Phenomenon

Customer's pre-production using TLV320AIC3101:

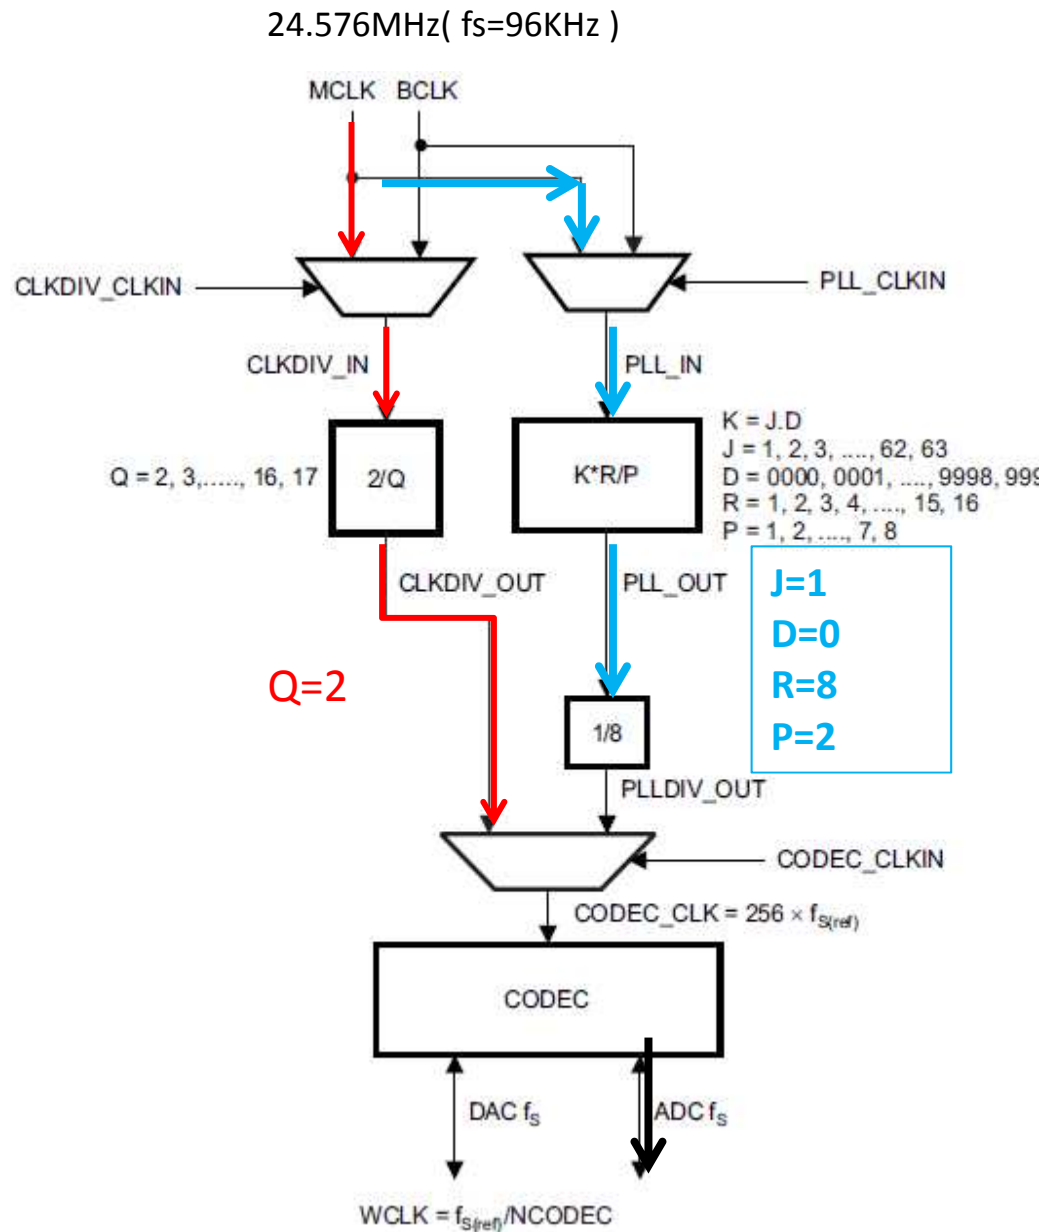
SNR of ADC output (I2S) is tested by Customer using AP.

6dB worsen(86dB) in case Red (PLL disable).
In case Blue line (PLL enable), customer saw 92dB .

This phenomenon occur just in case CLK in=24.576($f_s=96\text{KHz}$) or CLK_in= 22.5792MHz.

In case $F_s=44.1\text{kHz}$: 11.2896MHz

$F_s=48\text{kHz}$: 12.288MHz, this phenomenon does not occur. Customer also says this is seen in ADC/double rate only.

In case DAC (i2s from AP) no problem even in Red line/double rate.

Would you please give us your advise/opinion about this?

(Frankly speaking, SNR in 96KHz is not specified on data sheet, but Please give your comment/advise)
